ADDENDUM

ADDENDUM NO.: **01**

PROJECT NAME: **Lake View High School Renovation Project**

DATE OF ISSUE: **April 19, 2017**

A4.0

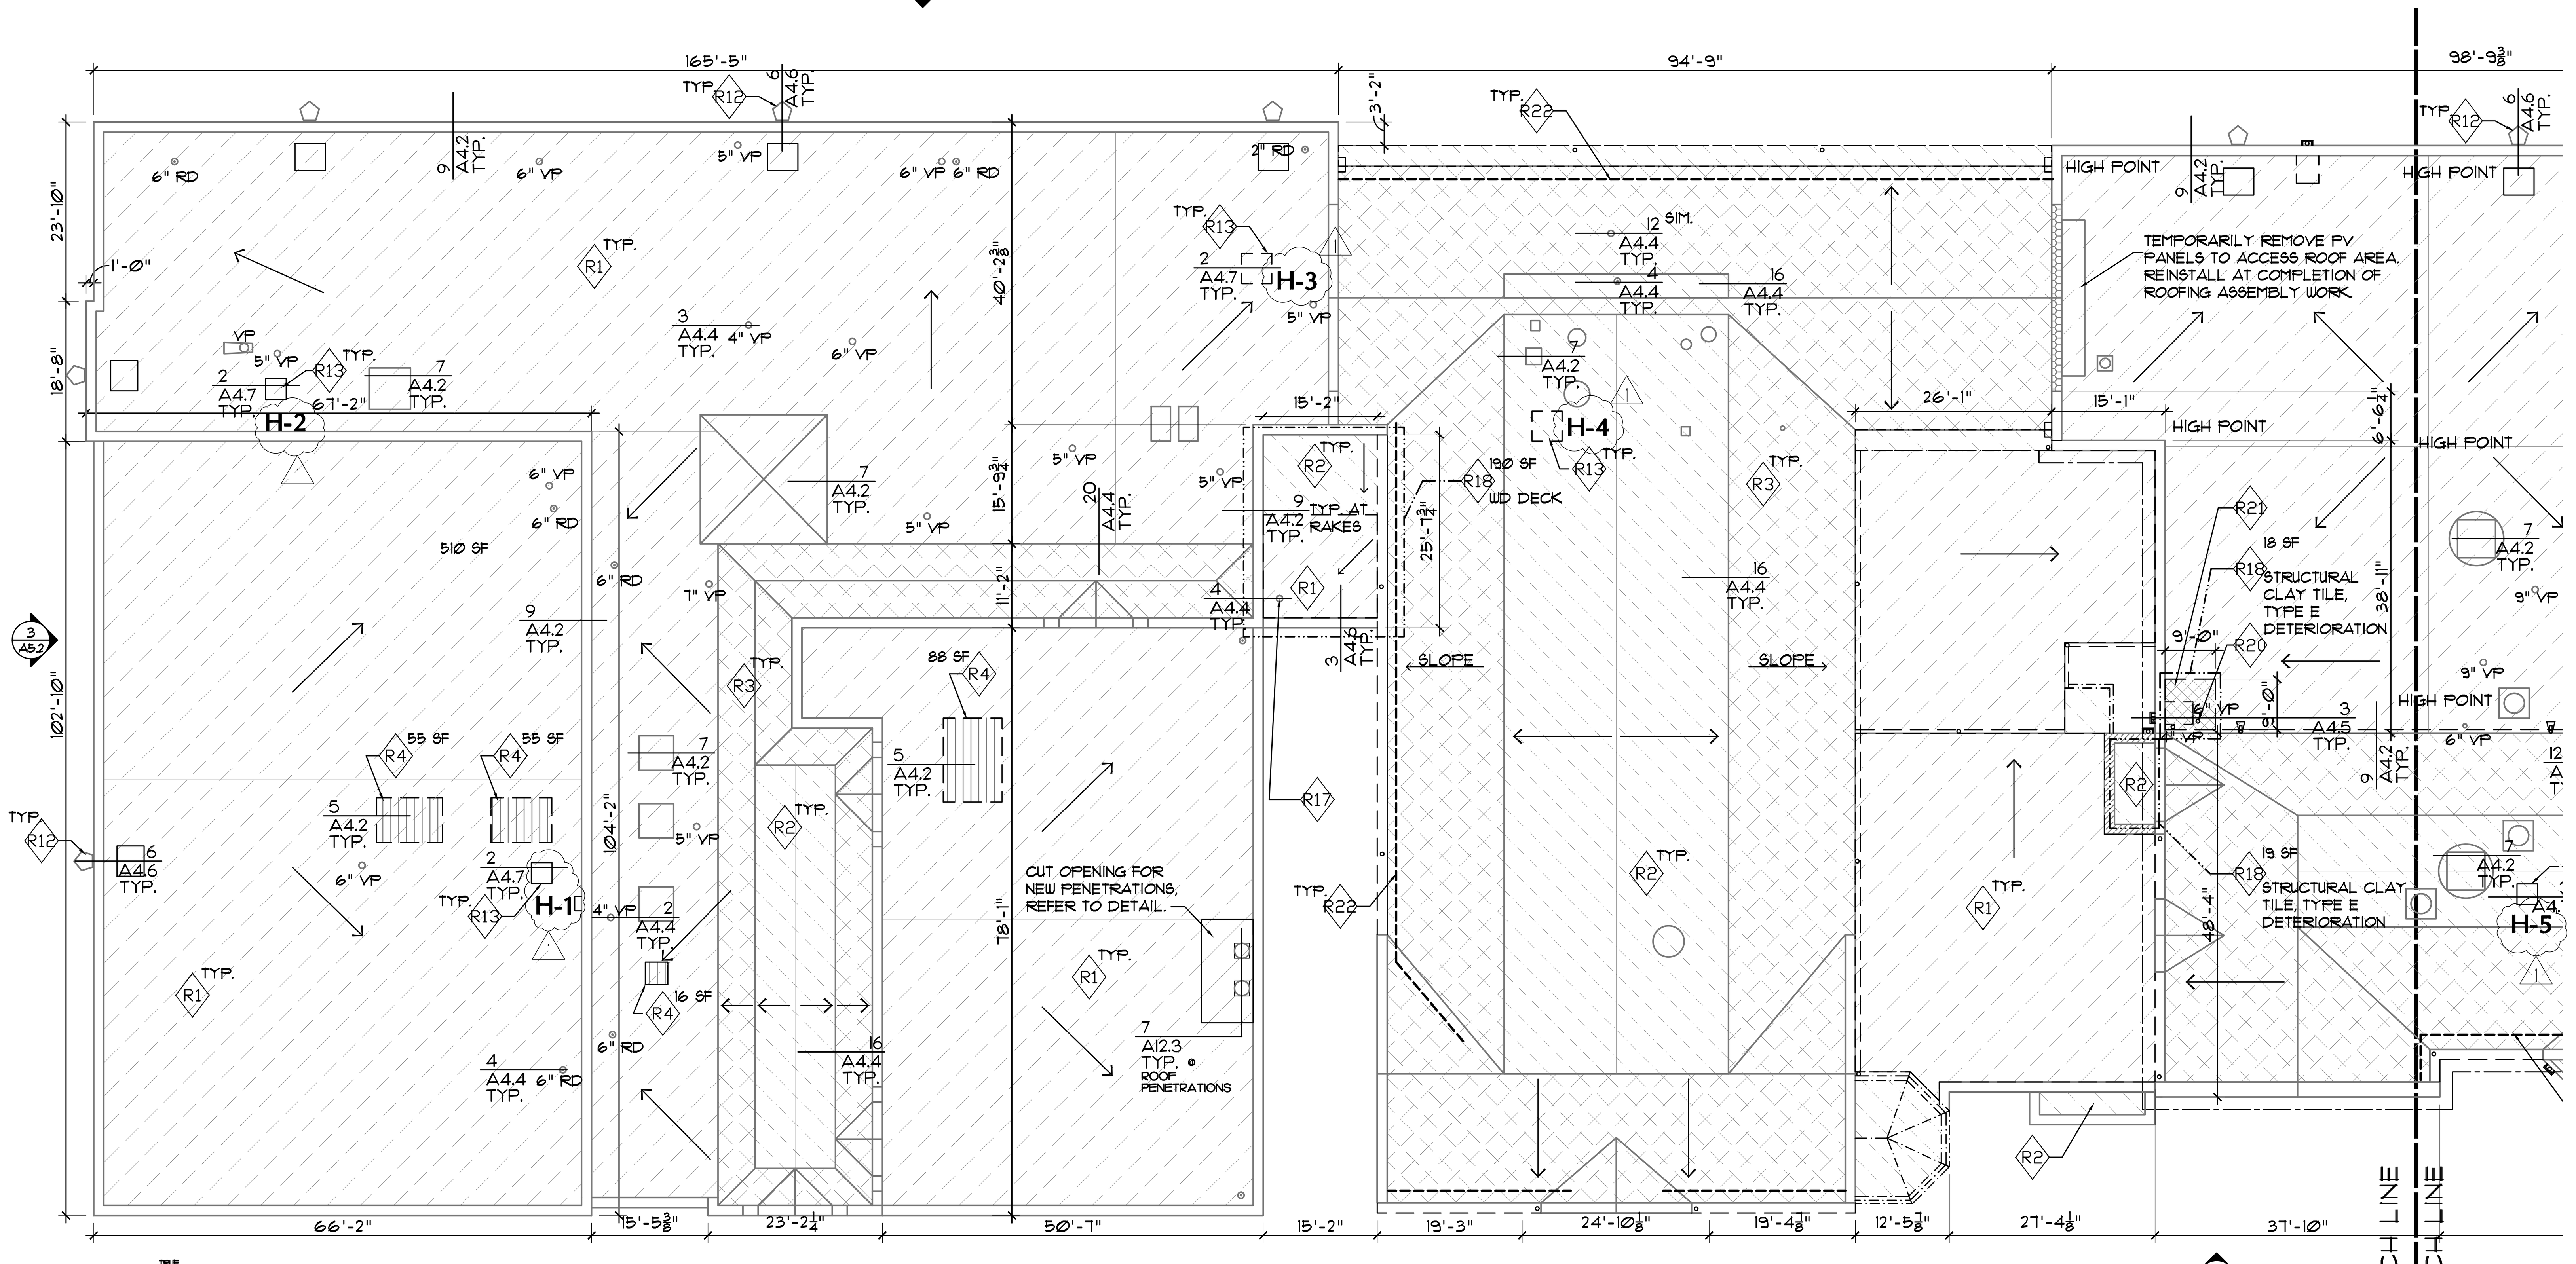
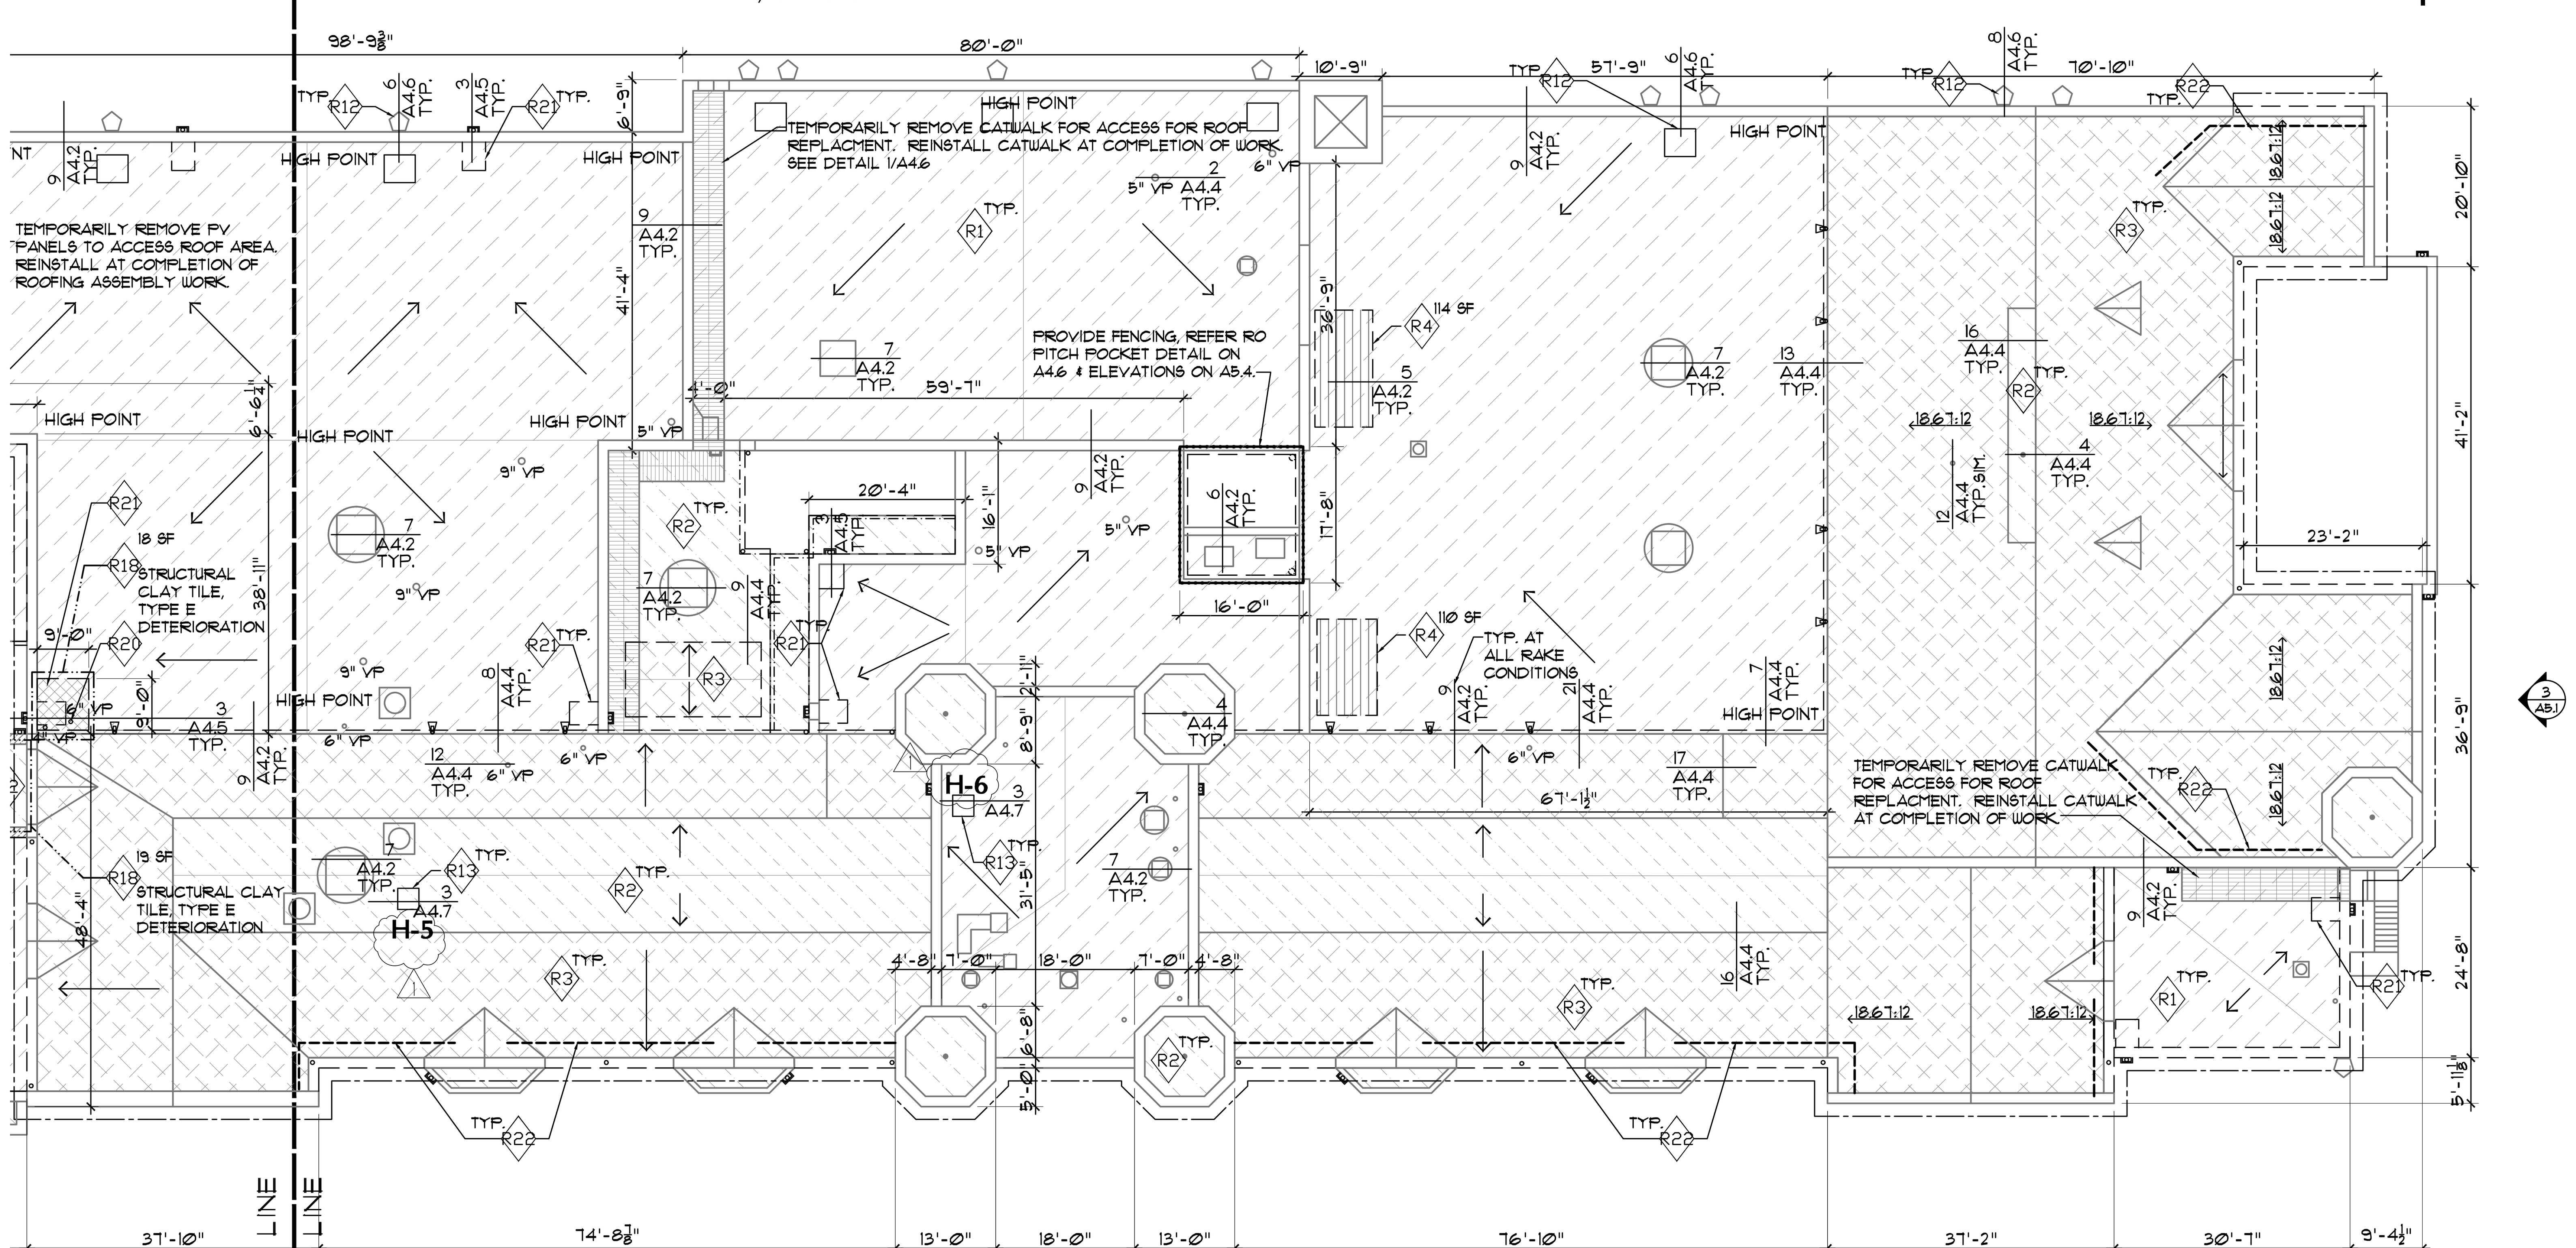
a. **REVISED** Drawing No. A4.0, ROOF DEMOLITION PLAN: Details 1 and 2 revised to clarify roof hatch types.
b. **REVISED** Drawing No. A5.1, BUILDING ELEVATIONS: Details revised to show all window types (for reference for manual shades, window trim refinishing, etc.). Existing window A/C unit removal / reinstallation scope also clarified.
